Panel Report

Whitehorse Planning Scheme Amendment C175

Box Hill Metropolitan Activity Centre

6 October 2017

Figure 4: Extract of Character Precincts from Built Form Guidelines

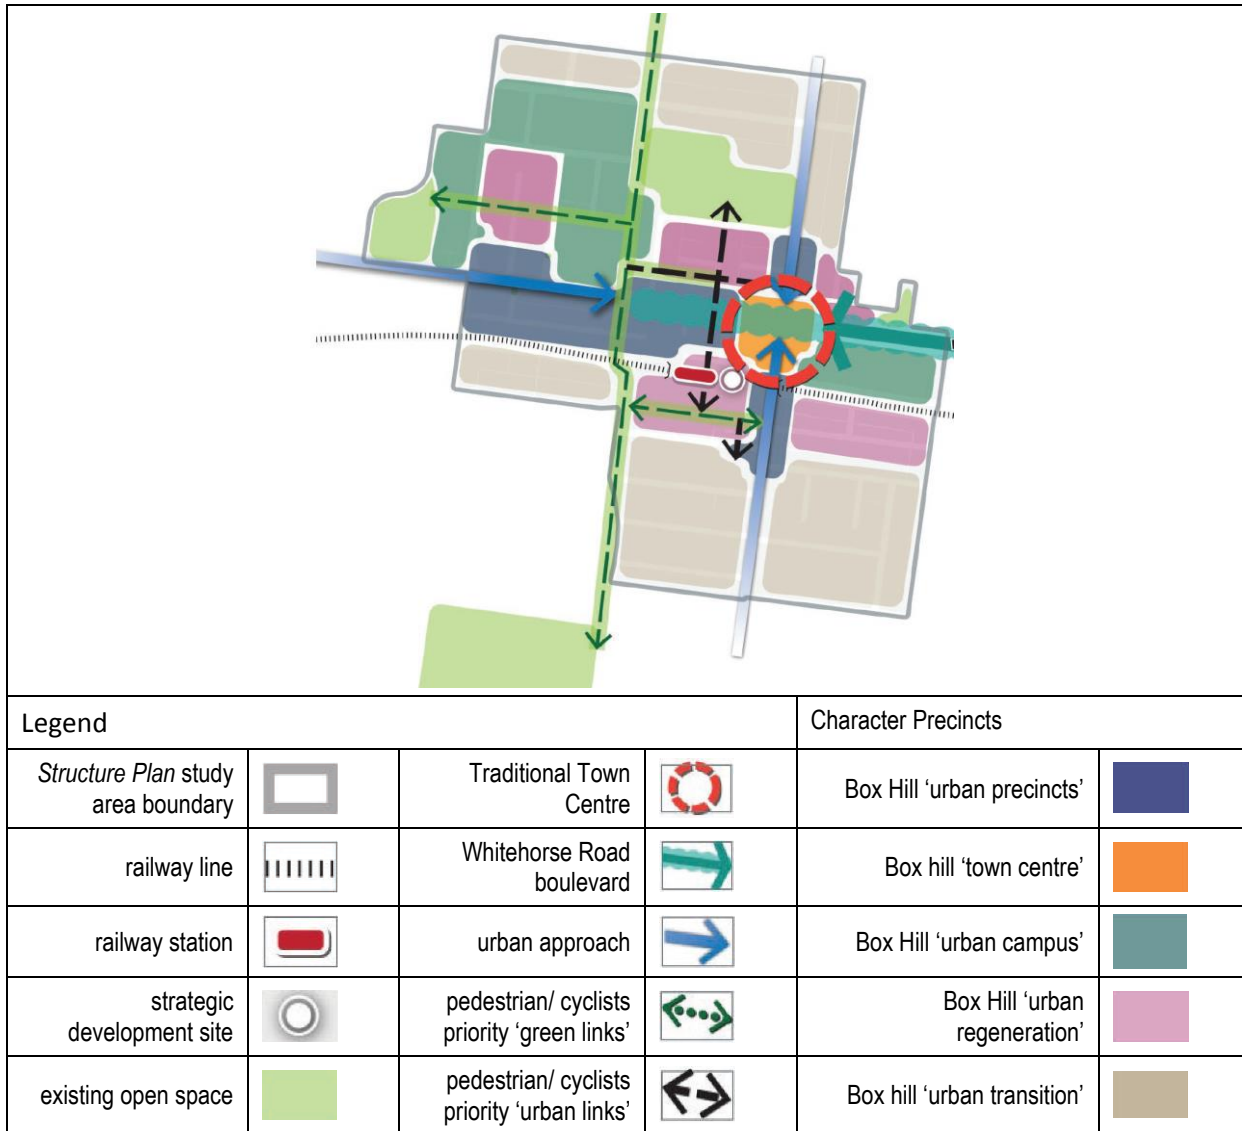
There is no clear relationship between the Character Precincts and the heights specified in the sub-precincts as shown in Figure 2; Table 4 shows the relationship between the character precincts and the sub-precincts that specify the built form controls.

Figure 5: Cross-section with height limits (approximately only) in green – Whitehorse Road

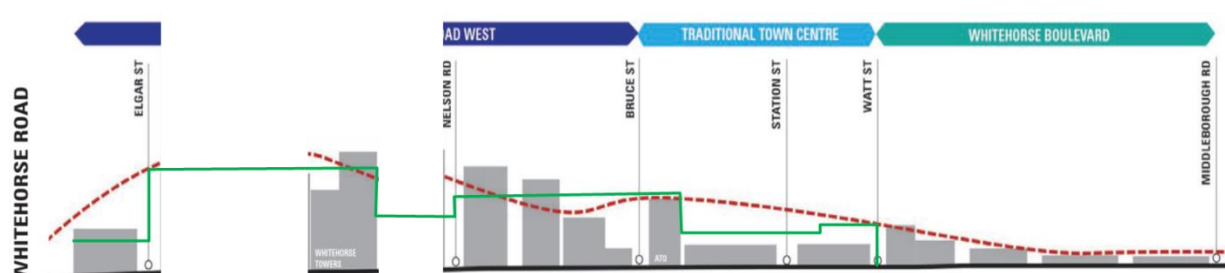
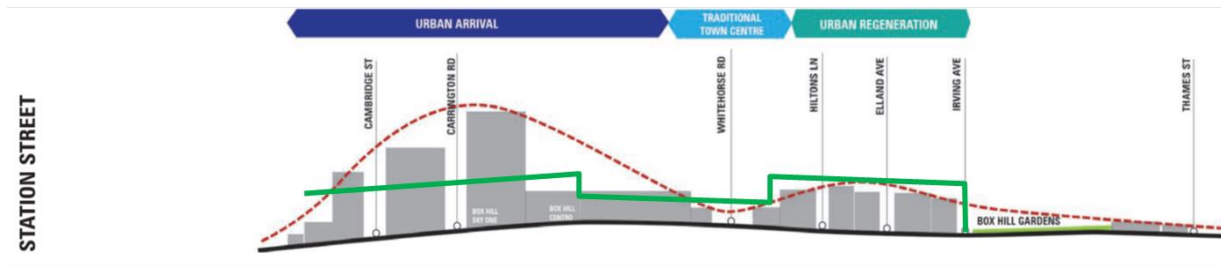
- there is an error in Whitehorse Road with part of the cross-section missing, (or not drawn to scale)
- there is no discernible connection between what has been approved and the proposed heights
- there is no connection between the sweeping red line and the proposed heights.

It is clear that the cross-sections identified on page 27 do not relate to current approvals and do not inform the height limits proposed.
